STATEMENT OF ENVIRONMENTAL EFFECTS – S4.55
PROPOSED DWELLING
198 HENRY LAWSON DRIVE
GEORGES HALL 2198

Issued: 17/10/2024

This Statement of Environmental Effects has been prepared to accompany a S4.55(2) modification to the approved Development Application (DA) **DA-667/2017/A** to the City of Canterbury-Bankstown Council (Bankstown) seeking consent for the demolition of existing structures and the construction of a two-storey dwelling house at **198 Henry Lawson Drive, George Hall**.

Figure 9. South East Elevation for S4.55(2) submission prepared by Alvaro Architects.

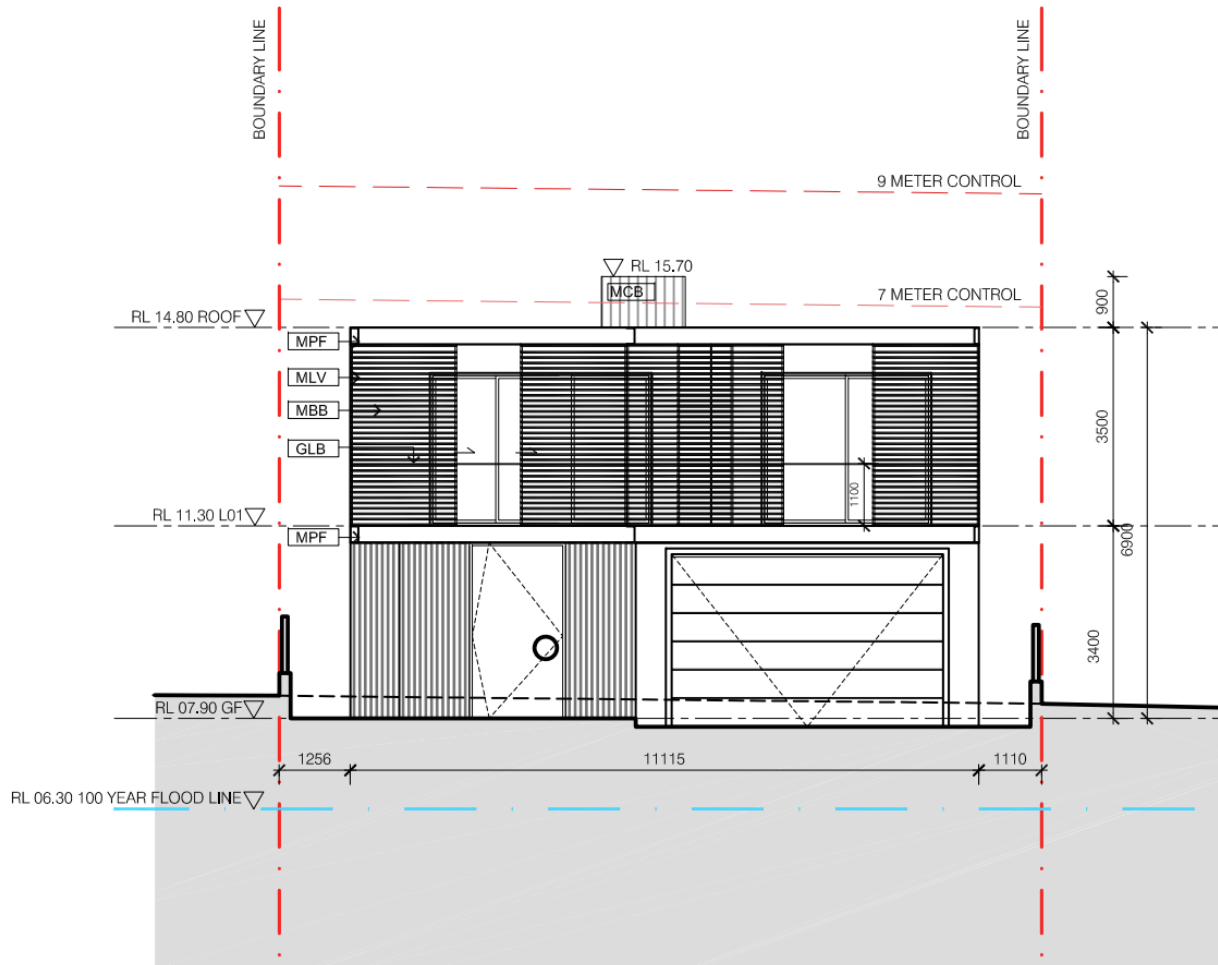
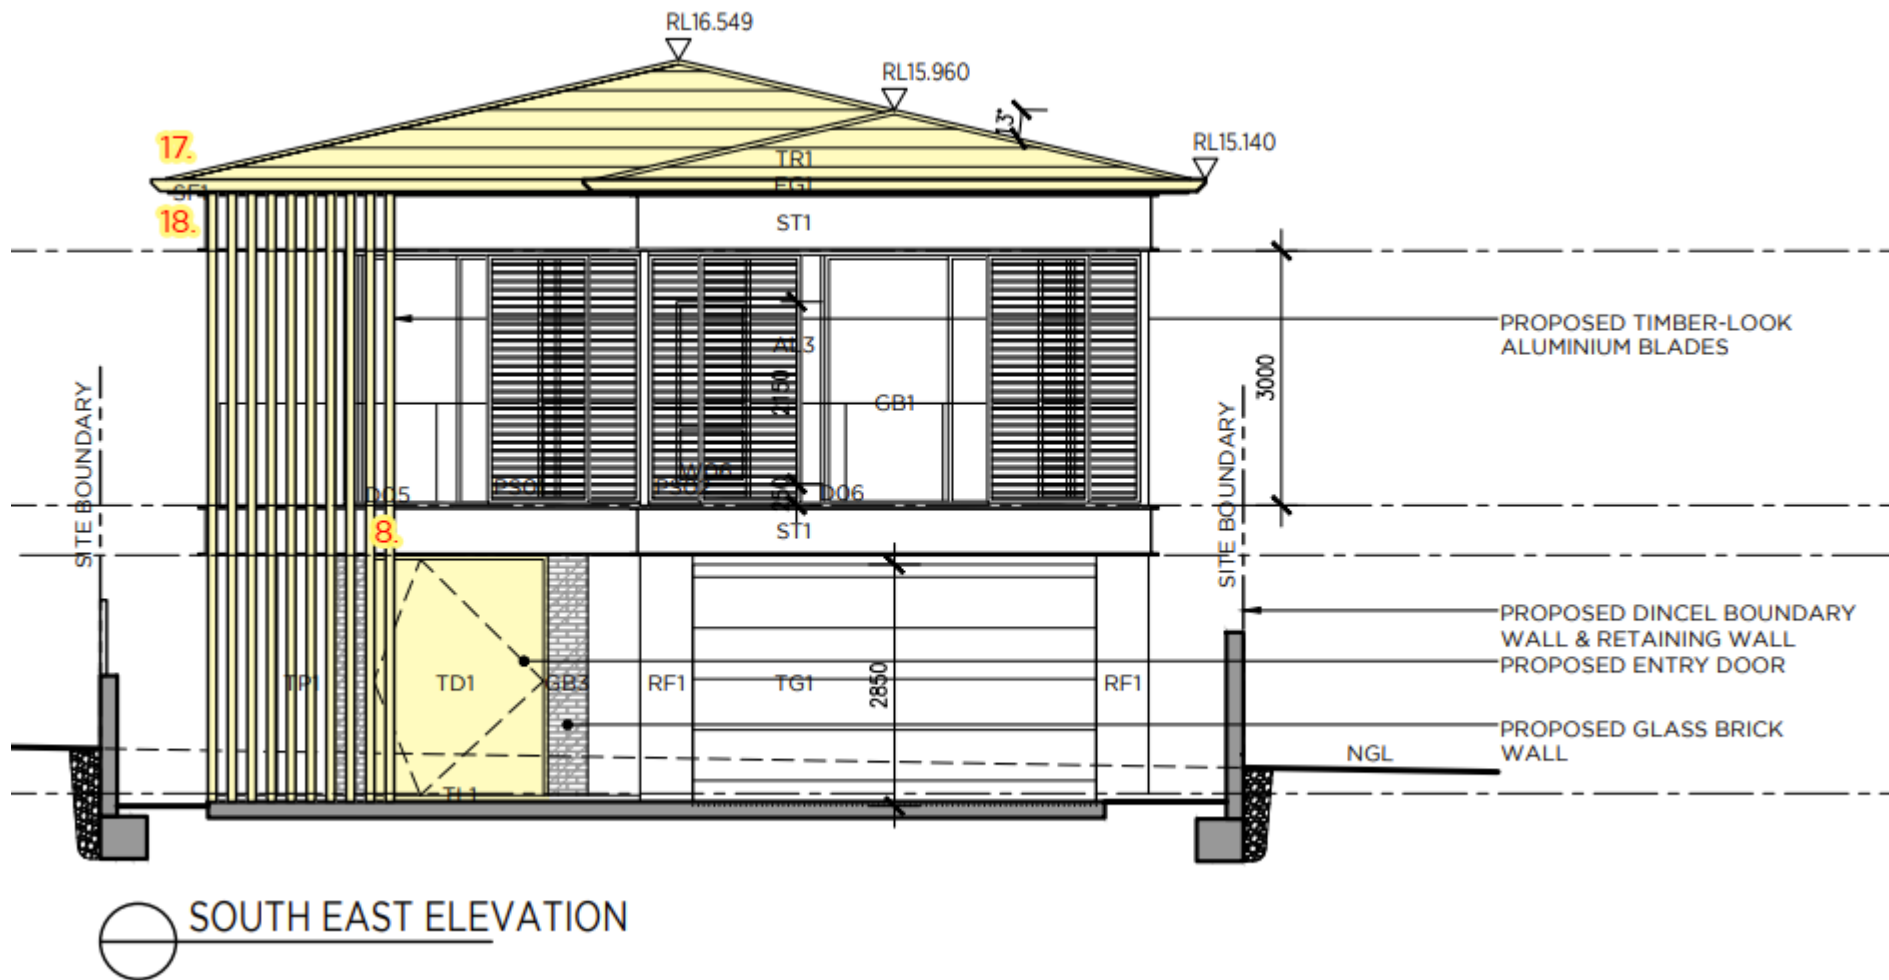
- 18. Timber-look aluminium blades proposed to street elevation to further define entry.

Refer to Figures 8. and 9. for a comparison of the South East Elevation submitted for **DA-667/2017/A** and the South East Elevation for this S4.55(2) submission, with the above modifications highlighted in yellow and numbered.

Figure 10. North East Elevation for DA-667/2017/A prepared by PTW Architects.

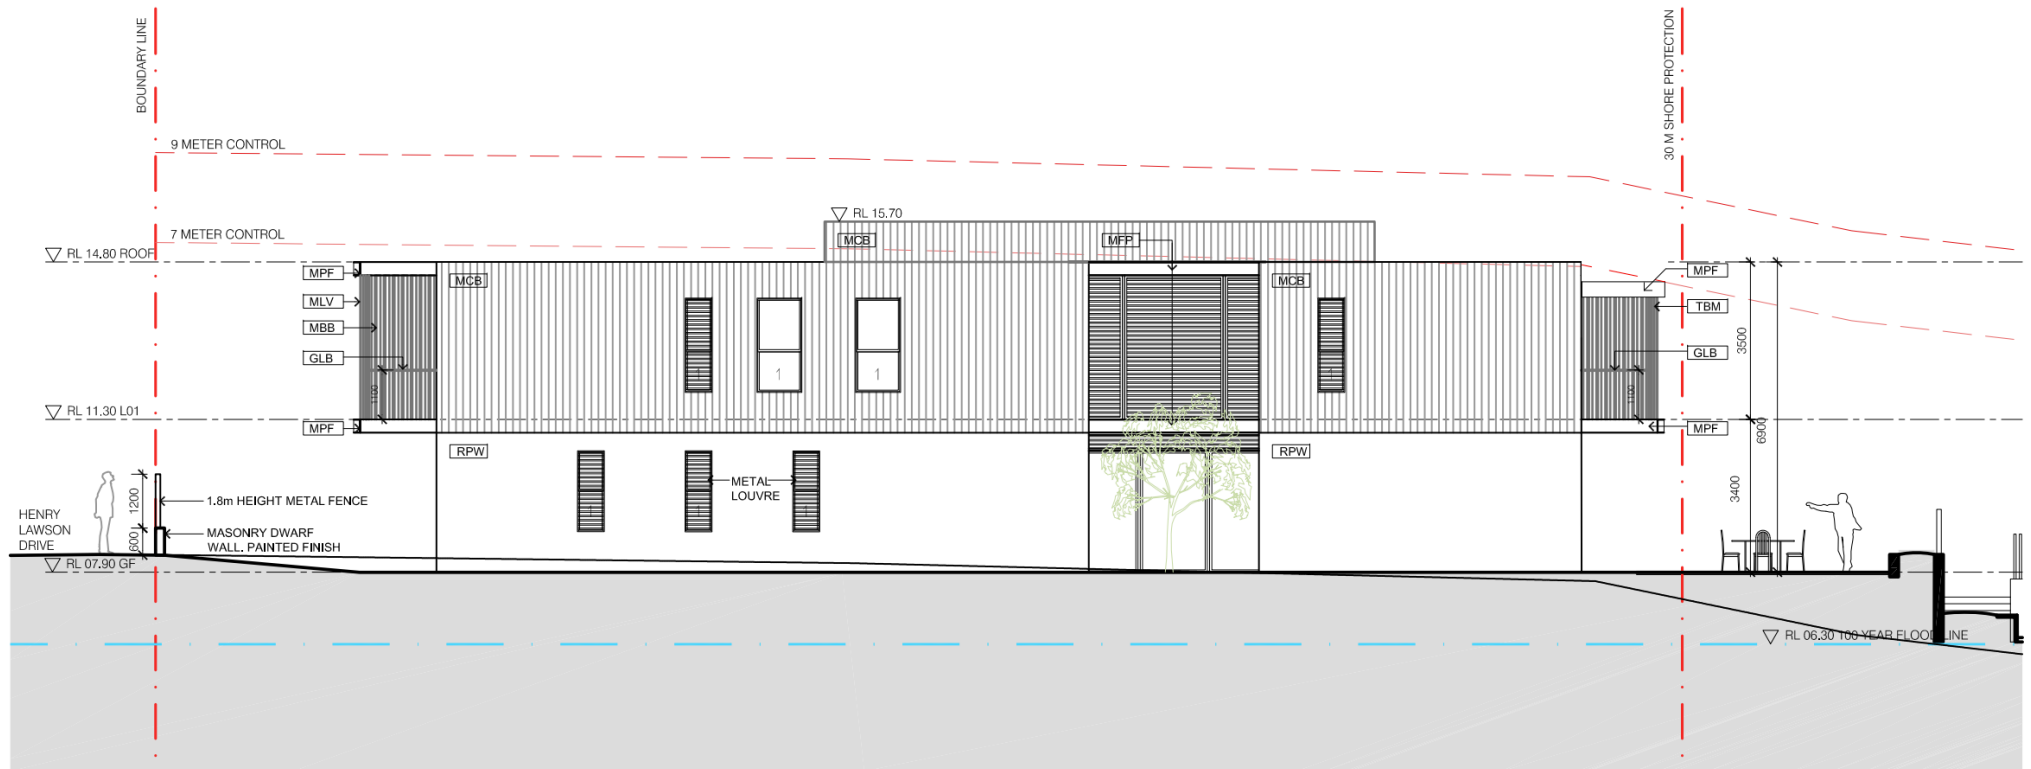
- 19. Window W10 proposed for Bed 02.
- 20. Glass block wall, GW01 & GW02, proposed to stair/lift well.

Refer to Figures 10. and 11. for a comparison of the North East Elevation submitted for **DA-667/2017/A** and the North East Elevation for this S4.55(2) submission, with the above modifications highlighted in yellow and numbered.

Figure 12. South West Elevation for DA-667/2017/A prepared by PTW Architects.

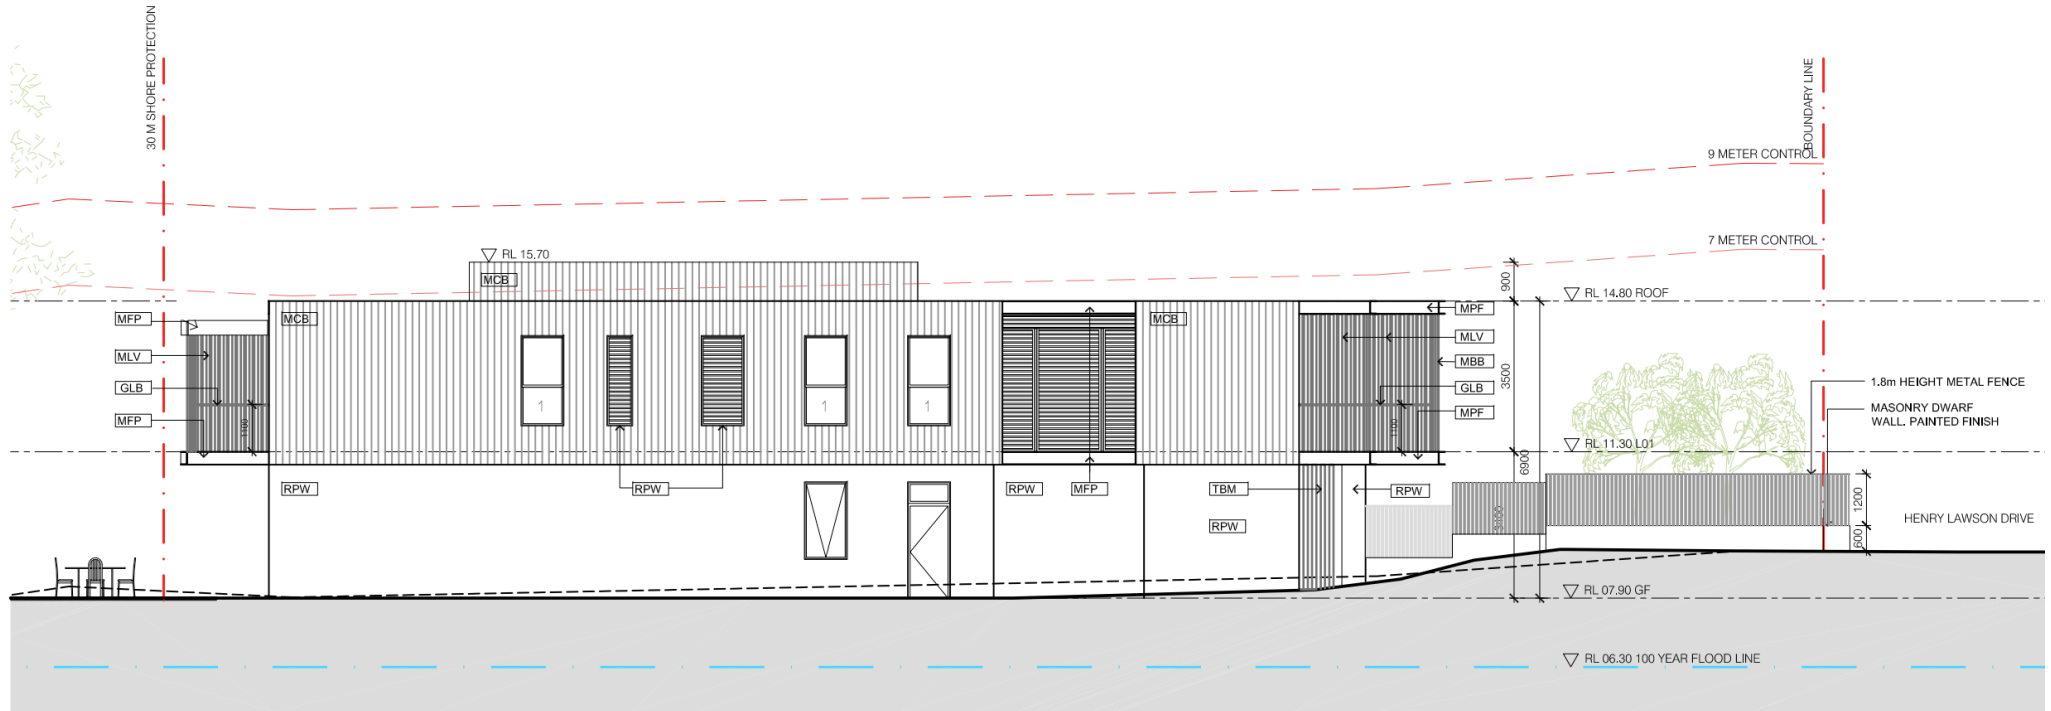
- 21. Window W14 reduced in width for Master Bed Walk in Robe.
- 22. Window W18 proposed for first floor Bathroom.
- 23. Window W19 proposed for Bed 04.

Refer to Figures 12. and 13. for a comparison of the South West Elevation submitted for **DA-667/2017/A** and the South West Elevation for this S4.55(2) submission, with the above modifications highlighted in yellow and numbered.
